POLLUTION CONTROL HEARINGS BOARD  
FOR THE STATE OF WASHINGTON

1			
2			
3			
4			
5	AIRPORT COMMUNITIES	)	No. 01-133
6	COALITION,	)	
7	Appellant,	)	DECLARATION OF WILLIAM A.
8	v.	)	ROZEBOOM IN SUPPORT OF ACC'S
9	STATE OF WASHINGTON,	)	MOTION FOR STAY
10	DEPARTMENT OF ECOLOGY; and	)	(Section 401 Certification No.
11	THE PORT OF SEATTLE,	)	1996-4-02325 and CZMA
12	Respondents.	)	concurrency statement, issued August
13			10, 2001, Related to Construction of a
14			Third Runway and related projects at
15			Seattle Tacoma International Airport)

Walker Ck Streamflow Analysis Fig B

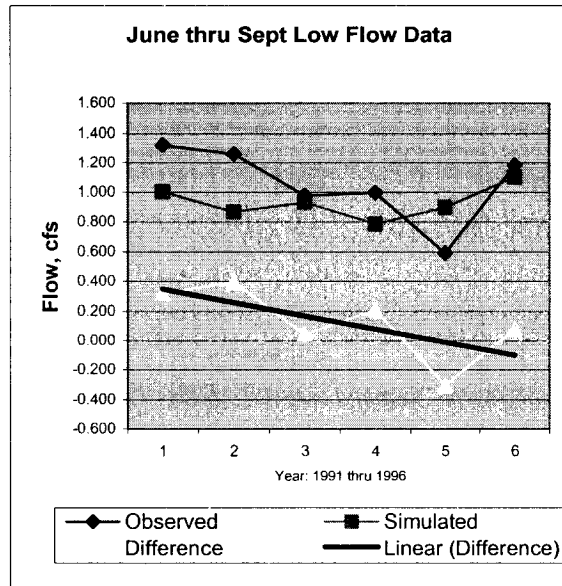
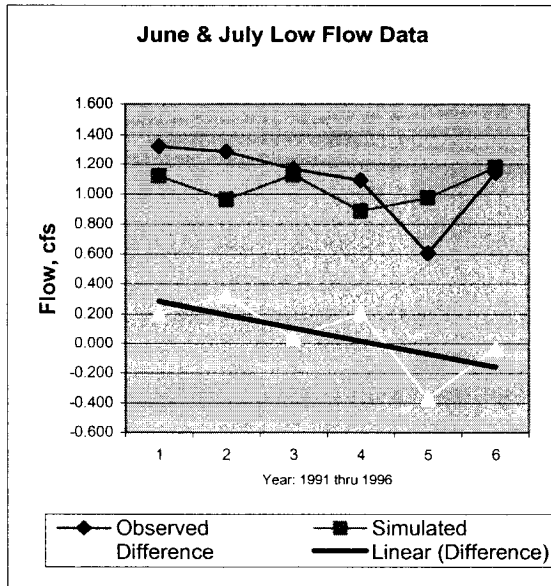
1           11.     We have commented previously that Walker Creek appears to be vulnerable to  
2 low streamflow reductions as a result of impervious surface diversions to the Industrial  
3 Wastewater System. This comment was based on groundwater mapping shown by SMP Figure  
4 B2-23 which showed that the IWS service area covers nearly half of the non-contiguous  
5 groundwater recharge area for Walker Creek. We speculated that IWS expansion, and IWS leak  
6 reduction activities, could potentially cause progressive reductions in low streamflows. The low  
7 flow report's calibrated Walker Creek HSPF model data and the corresponding recorded data  
8 provides the basic information necessary to examine whether changes in streamflow are in fact  
9 occurring, unrelated to climatic variability.  
10
